Reply to Referee 2 by Borowski et al..

Borowski et al. provide an interesting assessment of the impact of inter-annual variability on long-term wind speed estimates. The topic is a valuable one and the authors did a nice job with their research design and analysis. I especially appreciate the helpful tables describing the observational sites and the variety of ML models considered. The manuscript is a bit challenging to follow at times, with references to analyses discussed much later in the text than the reader’s current location, but the findings are nicely summarized in the discussion section.

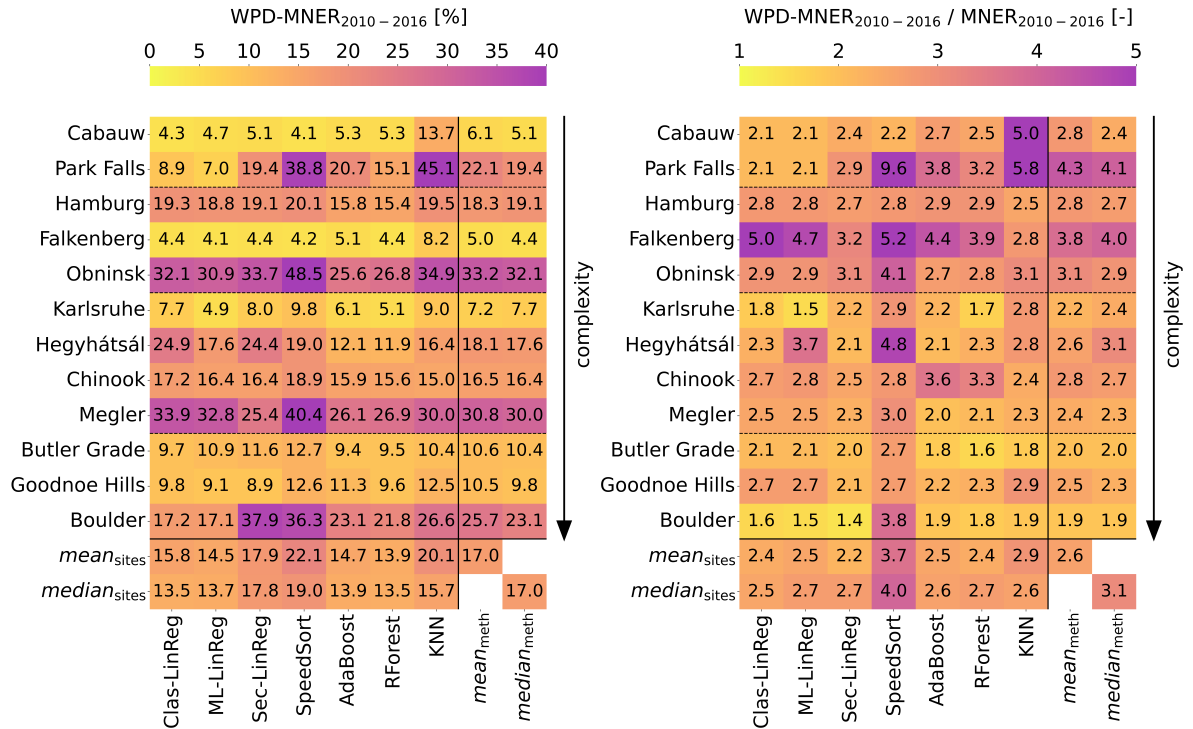
Comment: This paper’s value to the wind energy community would benefit significantly if the results were translated into an energy parameter in the discussion. In particular, I could see great value by running the various wind speed time series through a reference turbine power curve and then speaking to the findings in terms of capacity factor ranges.

⇒ Thank you for this valuable comment. We agree that translating the results into an energy parameter could enhance the paper’s relevance to the wind energy community. However, using a single reference

turbine power curve for all sites might introduce a bias, as turbines are typically selected based on site-specific wind conditions, which vary significantly across the investigated sites. To address this and providing meaningful energy-related insights, we additionally calculated the “mean normalize ensemble range” (MNER) for wind power density (WPD) at each site, as well as, the factor between MNER of wind power density and wind speed and included both as Figure and corresponding text in Section 3.3 (initial manuscript). This approach allows us to express the results in terms of wind energy potential while avoiding using a turbine power curve for all locations. The following additions to the manuscript were made:

Result Section 3.3 (line 274): “The relationship between wind power density and wind speed is cubic and therefore, uncertainty in estimating wind speed significantly impacts the uncertainty of wind power density and annual energy potential. The translation of wind speed uncertainty to annual energy potential uncertainty is not consistently defined. Holtslag (2013) state that 1 % uncertainty in wind speed is related to 1.8 % in annual energy potential. EMD (2025) give the rough orientation that in regions with low wind speeds ($6-7 \text{ m s}^{-1}$), wind speed uncertainty should be tripled for annual wind potential uncertainty while it is only doubled for higher wind speeds (about 8 m s^{-1}) and only 1.5 times at regions with even higher wind speeds (about 9 m s^{-1}). To connect the MNER of wind speed (Fig. 8) to a more comprehensive energy parameter, the MNER for wind power density (Fig. 9, left) is calculated.

Additionally, the factor (Fig. 9, right) between the MNER of wind speed and wind power density is determined. The results indicate that, on average, a factor of approximately three (2.6) is achieved. Further, the factor between MNER of wind speed and wind power density does not increase with complexity. But, the studied sites have averaged wind speeds ranging from approximately 5 m s^{-1} to 7 m s^{-1} (Table 1), which suggests that the roughly tripled uncertainty aligns with the results from EMD (2025)."
